Well Name: BOLL WEEVIL 27-34 FED COM	Well Location: T26S / R34E / SEC 27 / NWNE / 32.021 / -103.4551	County or Parish/State: LEA / NM
Well Number: 6H	Type of Well: OIL WELL	Allottee or Tribe Name:
Lease Number: NMNM100569	Unit or CA Name:	Unit or CA Number:
US Well Number: 3002547953	Well Status: Approved Application for Permit to Drill	Operator: DEVON ENERGY PRODUCTION COMPANY LP

Sundry ID: 2761987

Type of Submission: Notice of Intent	Type of Action: APD Change
Date Sundry Submitted: 11/16/2023	Time Sundry Submitted: 12:56
Date proposed operation will begin: 11/16/2023

BOLL WEEVIL 27-34 FED COM 6H

Well: BOLL WEEVIL 27-34 FED COM 6H
County: Lea
Wellbore: Permit Plan
Design: Permit Plan #1

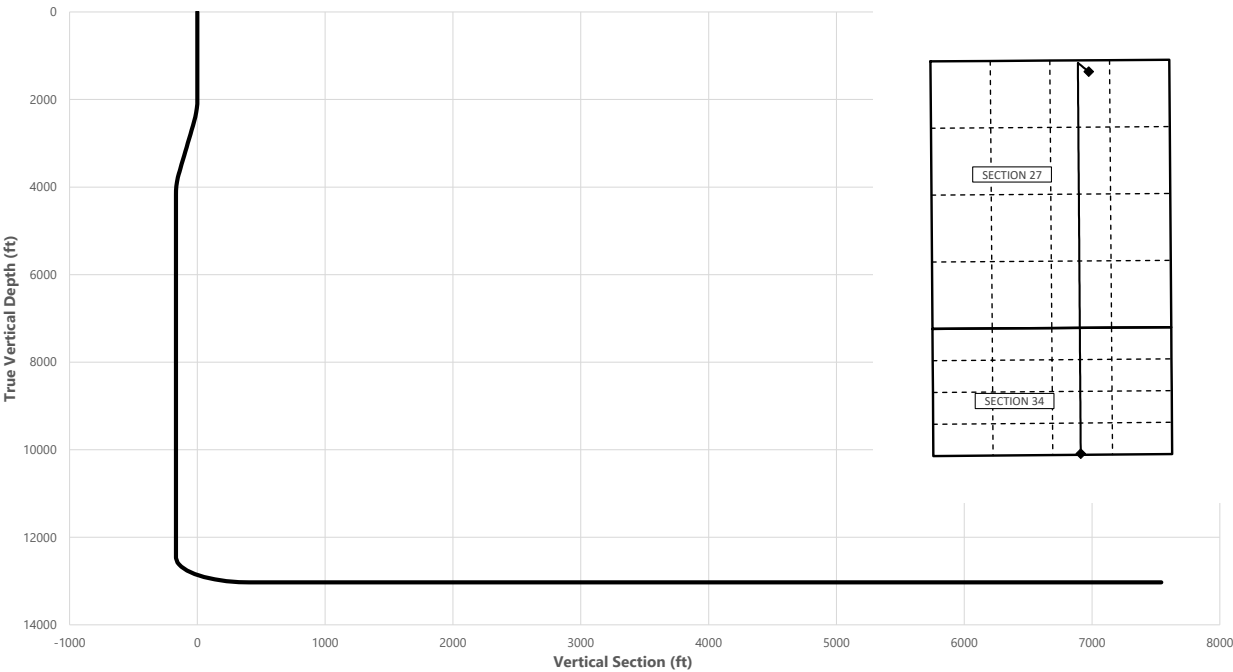
TVD/MD change from 12800/20269 to 13030/20521'

MD	TVD	Lat	Long	Section Footages
(ft)	(ft)	(°)	(°)	
0.00	0.00	32.0210	-103.4551	225' FNL, 1784' FEL of Sec 27 in T26S, R34E
12480.27	12457.04	32.0214	-103.4559	50' FNL, 2021' FEL of Sec 27 in T26S, R34E
12645.51	12620.00	32.0214	-103.4558	100' FNL, 2020' FEL of Sec 27 in T26S, R34E
20440.79	13030.01	32.0003	-103.4558	100' FSL, 2020' FEL of Sec 34 in T26S, R34E
20520.79	13030.00	32.0002	-103.4559	20' FSL, 2020' FEL of Sec 34 in T26S, R34E

WELL LOCATION AND ACREAGE DEDICATION PLAT

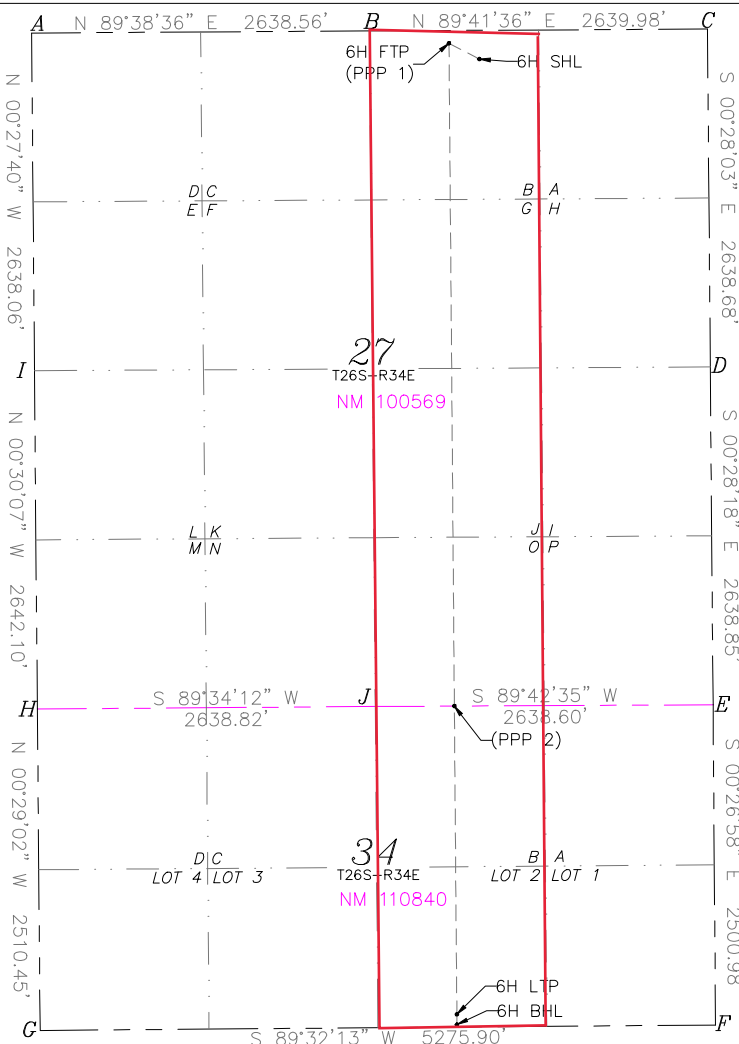
BHL change from 20 FSL & 1660 FEL to 20 FSL & 2020 FEL, both 34-26S-34E

Dedicated acreage change from 471.68 acs to 235.87acs.

UL or lot No.	Section	Township	Range	Lot Idn	Feet from the	North/South line	Feet from the	East/West line	County
2	34	26-S	34-E		20	SOUTH	2020	EAST	LEA

Dedicated Acres	Joint or Infill	Consolidation Code	Order No.
235.87
